AMF HARLEY-DAVIDSON SERVICE BULLETIN

No. M-749

SAFETY DEFECT 040

REAR BRAKE MASTER CYLINDER PUSH ROD / XLCR-1000

Rear Brake Master Cylinder - Exploded View

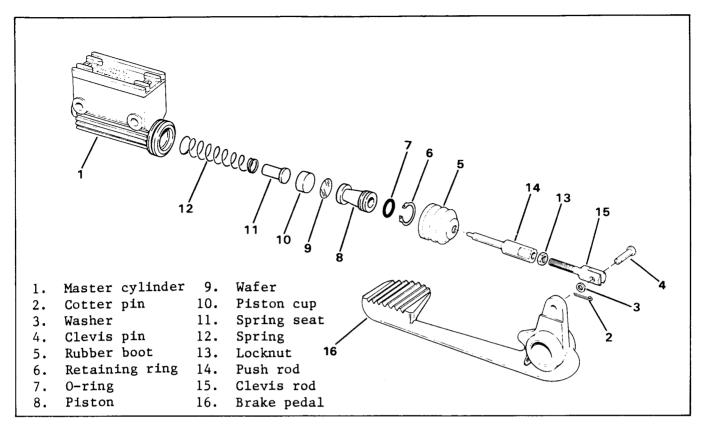
All XLCR-1000 motorcycles produced during the 1977 and 1978 model season were shipped with rear brake master cylinder push rods having insufficient contact area with the rear brake master cylinder plastic piston. In this condition it is possible that during extremely high brake pedal effort such as during an emergency stop, the brake rod could penetrate the master cylinder plastic piston, with possible loss of hydraulic pressure.

The no-charge shipment of this program will expire on November 15, 1979. After that time, any Kits which you order under special number 93269 will be charged to your account. Kit consists of Master Cylinder Repair Kit, part No. 42374-77 and larger Master Cylinder Push Rod, part No. 42312-80.

If any 1977 or 1978 XLCR motorcycles have been sold by you, we request that you contact the purchasers immediately, warn them of the inherent safety hazard, and make arrangements for installing the new, larger diameter push rod, and master cylinder repair kit.

Dip all internal parts from supplied piston kit in DOT 5 type brake fluid prior to assembly. Insert these new parts from kit into master cylinder in order shown in illustration. Make sure 0-ring is positioned in groove of piston before inserting piston into cylinder.

Loosen jamnut (13) and unscrew old push rod (14) from clevis rod (15). Install new push rod, part No. 42312-80 supplied to you, on clevis rod. Do not tighten jamnut until brake linkage is properly adjusted later.

Work brake pedal lever up and down by hand to determine free play before push rod contacts piston in master cylinder. Free play of push rod should be approximately 1/8 inch to be sure that master cyclinder pressure is relieved. To adjust free play, push rod on clevis rod threads - forward to decrease free play or rearward to increase free play. Adjustment should be made starting with linkage very loose, then adjusting push rod until 1/8 inch free play in the push rod is obtained. Tighten locknut (13).
